**Re: Grading and Drainage Certification – Townhomes at Sandia Plaza,
Engineer's Stamp dated 2-19-99 (G21/D39)
Engineering Certification dated 12-13-99**

***RE: Drainage Report and Grading and Drainage Plan for Townhomes at Sandia Plaza,
(G21/D39) Engineer's Stamp Dated 2/19/99.***

**DRAINAGE REPORT
FOR THE
TOWNHOMES AT SANDIA PLAZA**

GRADING & DRAINAGE CERTIFICATION

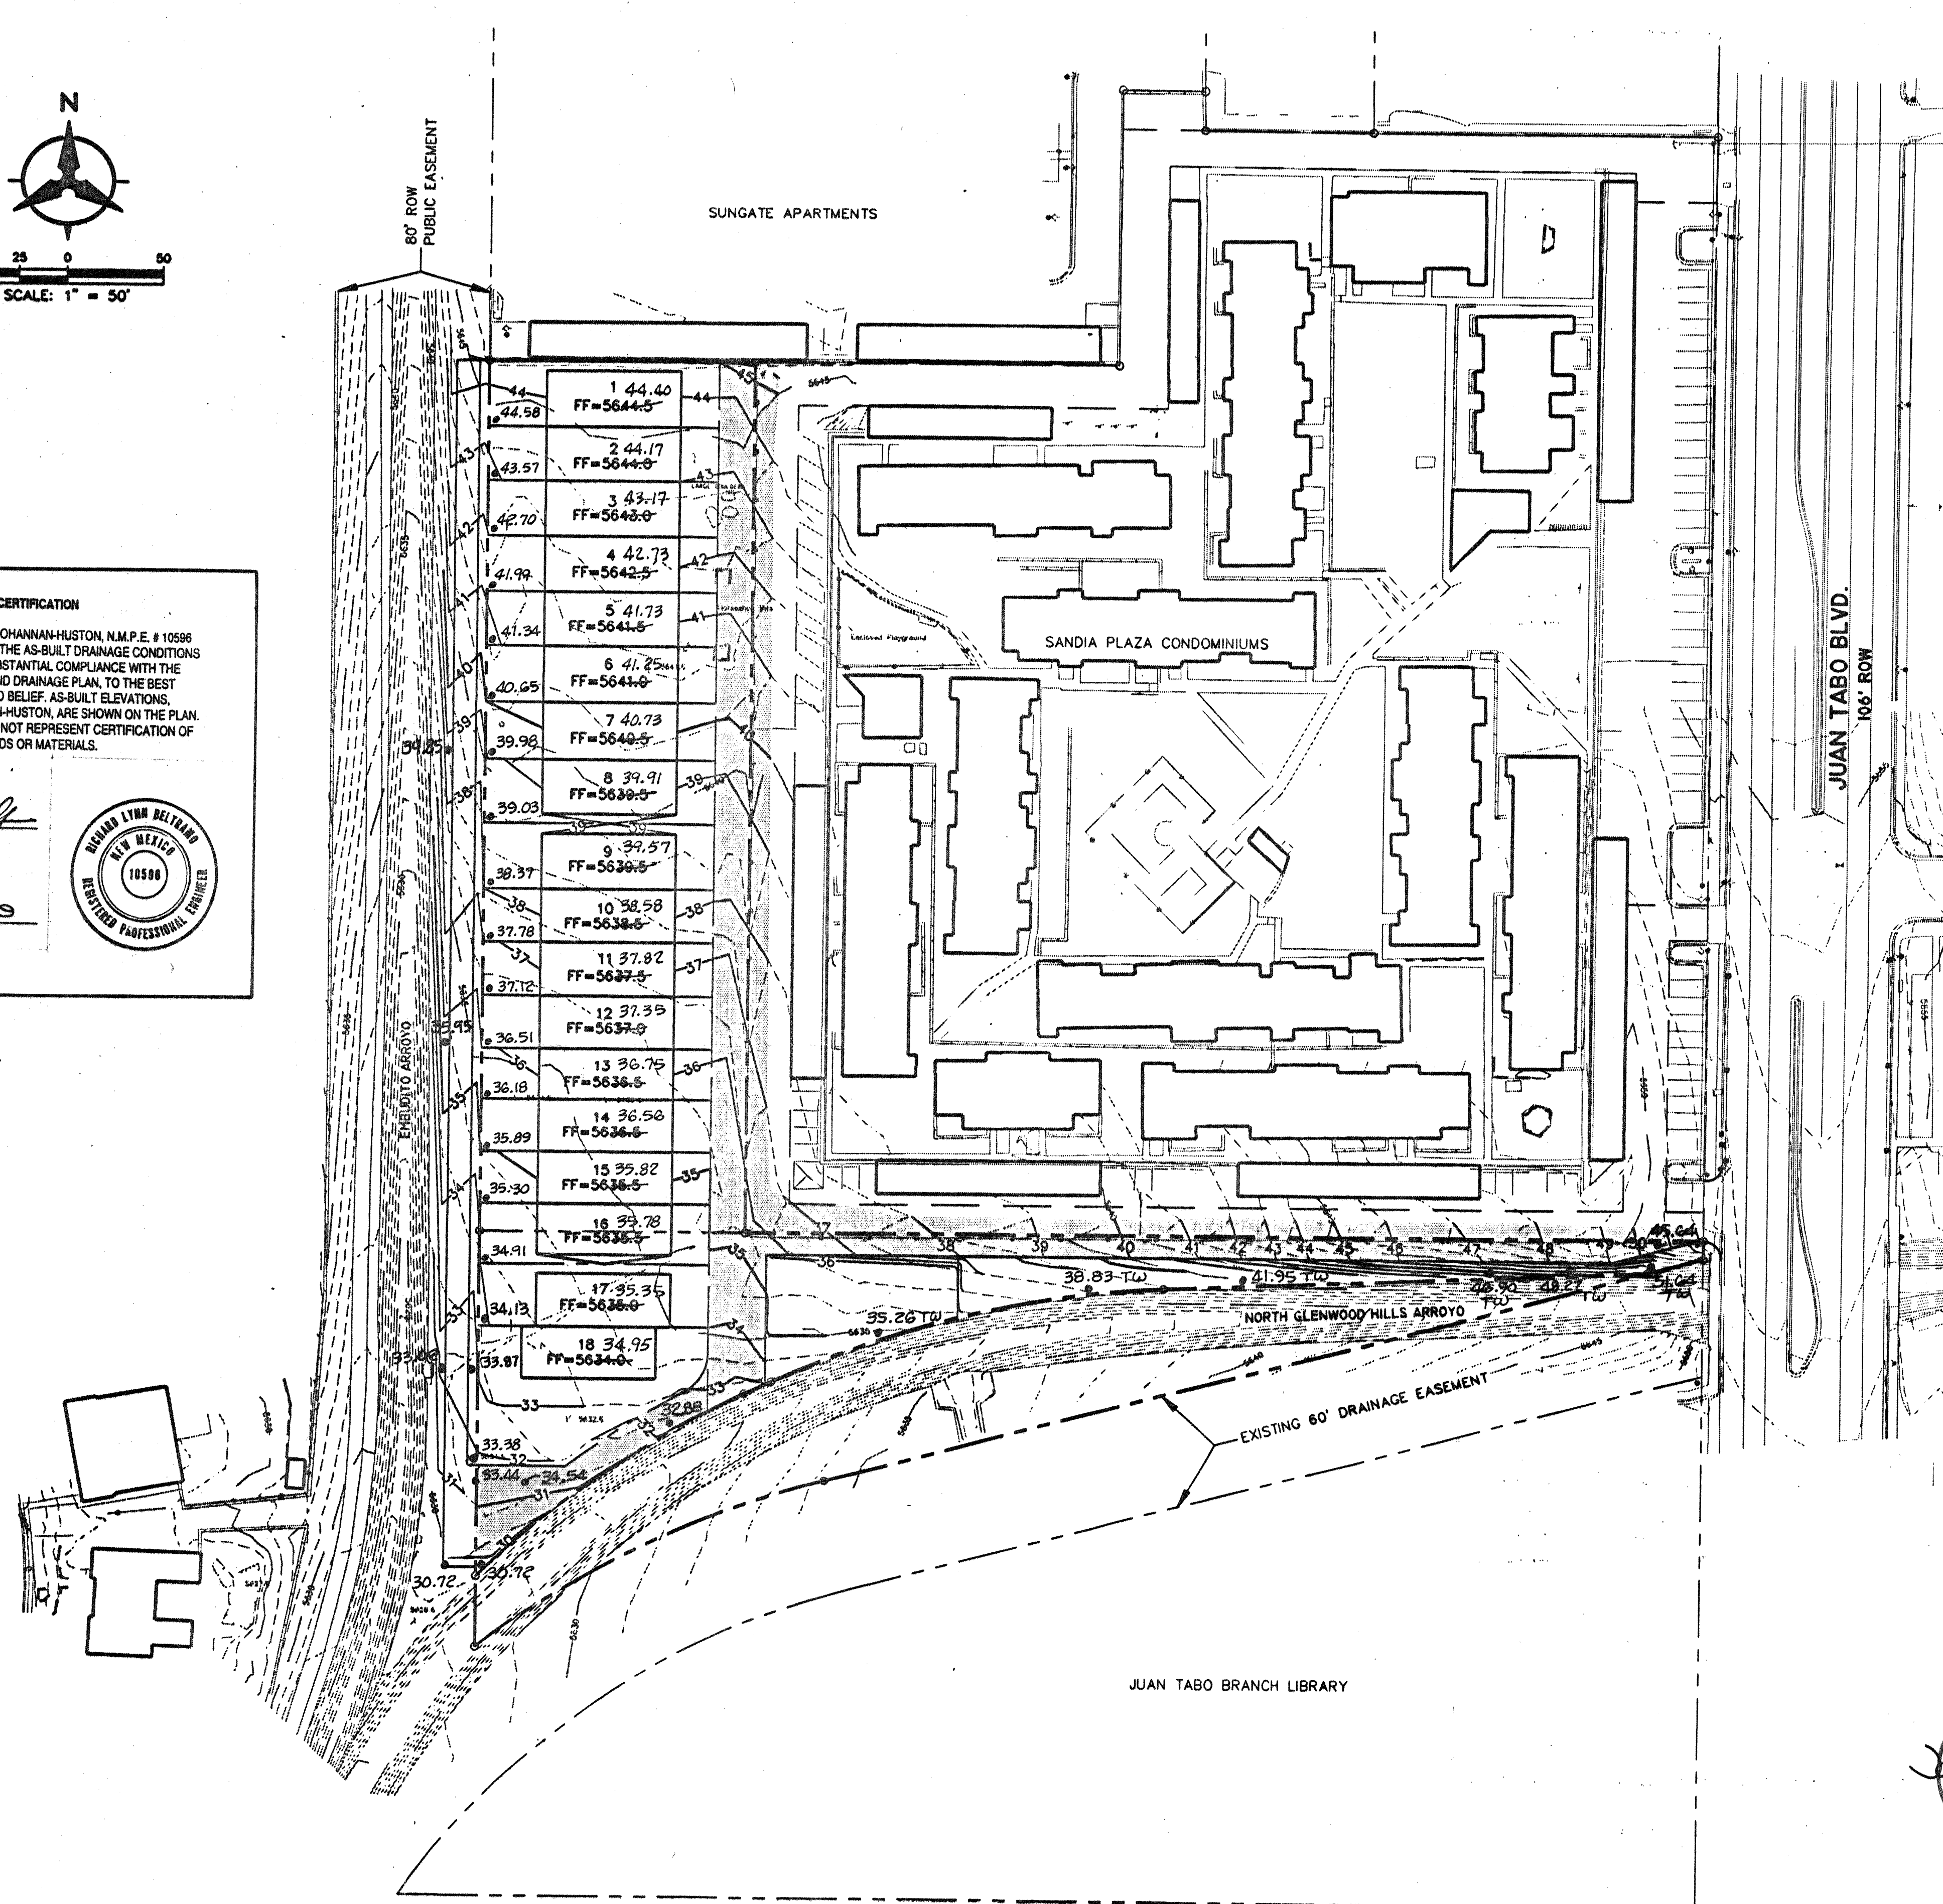
Prior to Final Plat or DRC approval, please provide a detail or note on the plan to indicate how the backyard flows are conveyed to the channel. Prior to Final Plat sign-off, the Subdivision Improvements Agreement (SIA) must be in place. As you are aware, the Grading and Drainage Certification of this approved plan is required prior to release of the SIA.

I, RICK BELTRAMO, OF BOHANNAN-HUSTON, N.M.P.E. # 10596
HEREBY CERTIFY THAT THE AS-BUILT DRAINAGE CONDITIONS
OF THE SITE ARE IN SUBSTANTIAL COMPLIANCE WITH THE
APPROVED GRADING AND DRAINAGE PLAN, TO THE BEST
OF MY KNOWLEDGE AND BELIEF. AS-BUILT ELEVATIONS,
VERIFIED BY BOHANNAN-HUSTON, ARE SHOWN ON THE PLAN.
THIS STATEMENT DOES NOT REPRESENT CERTIFICATION OF
CONTRACTOR'S METHODS OR MATERIALS.
